MOONEY AIRCRAFT INC.

~~Service Letter No.~~ 20-2 Rev. A

Subject: Inspection of weld joint attaching aileron counterweight Balance arm to Aileron Frame.

Revision Models Affected: M-20 Ser. No. 1003 thru 1051

FIGURE 1

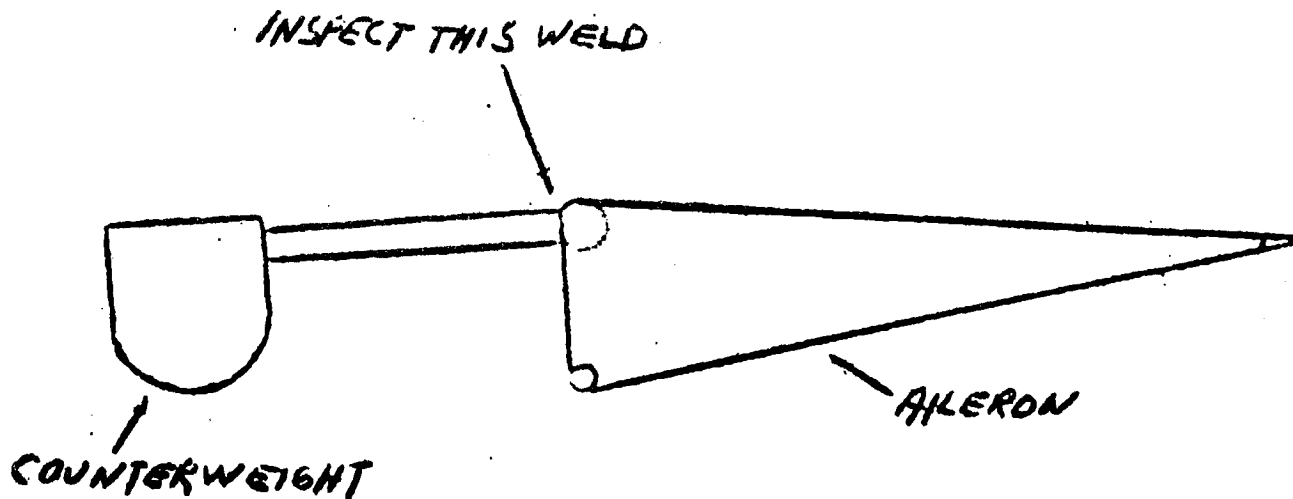
Due to the possibility of fatigue cracks at the weld attaching the aileron counterweight balance arm to the aileron frame it is requested that the following inspection be accomplished. Remove the aileron counterweight fairings. Remove the paint from the welded joint in question (see Figure 1) and inspect for cracks. If cracks are in evidence please inform the factory of the details. Suitable repair instructions will be furnished. If a repair is necessary the airplane should be grounded until it is accomplished.

Revision A: Time of Compliance: every 50 Hours until reinforcement added.*

Revision A: *Parts and instructions necessary to make this repair will be sent without charge upon request.
